Service Information Letter

RotorSport UK Ltd				
Poplar Farm, Prolley Moor, Wentnor, Bishops Castle, Shropshire, UK, SY9 5EJ				
SIL No.: 006 issue 1, dated 24.02.2011			CCAR No.: None	
Aircraft type & model (applicability) RotorSport UK MT-03, MTOsport, Calidus			Aircraft serial Nos. effected RSUK/MT-03/all, MTOsport/all, Calidus/all	
The purpose of this document is to communicate information to pilot owners of RotorSport aircraft that may be of benefit. If there is any clarification required of the content of the letter, contact RSUK on 44(0)1588 650769, or email info@rotorsport.org .				
<u>Subject</u> Rotax servicing – new oil filter			Issue date: 24.02.2011	
<u>Safety effect</u> No change				
<u>Weight and CG effect</u> Not significant				
<u>Background:</u> Rotax have announced a change in the manufacturing process of the canister oil-filter for 912 and 914-series engines. This results in the canister being some 3.5mm longer, for which a new part number has been issued.

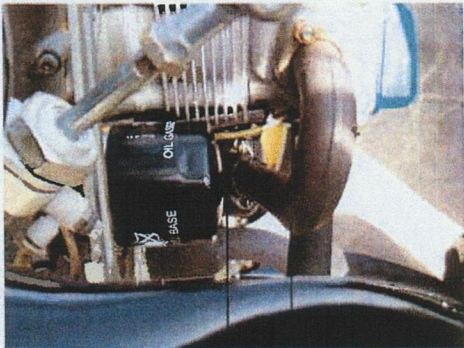
<u>Recommendation:</u> RSUK presently fit (and supply as a service item) part number 825706 (as RSD4421) for use on the 912ULS and 914UL engines installed in RSUK MT-03, MTOsport and Calidus aircraft. As this part is now discontinued by Rotax, when present RSUK stocks are exhausted part number 825012 (as RSD4615) will be fitted/supplied.				
RSUK have evaluated the new filter and whilst noting that access (between the engine crankcase and the exhaust) is made slightly more difficult the new filter may be readily fitted by inclining it during installation.
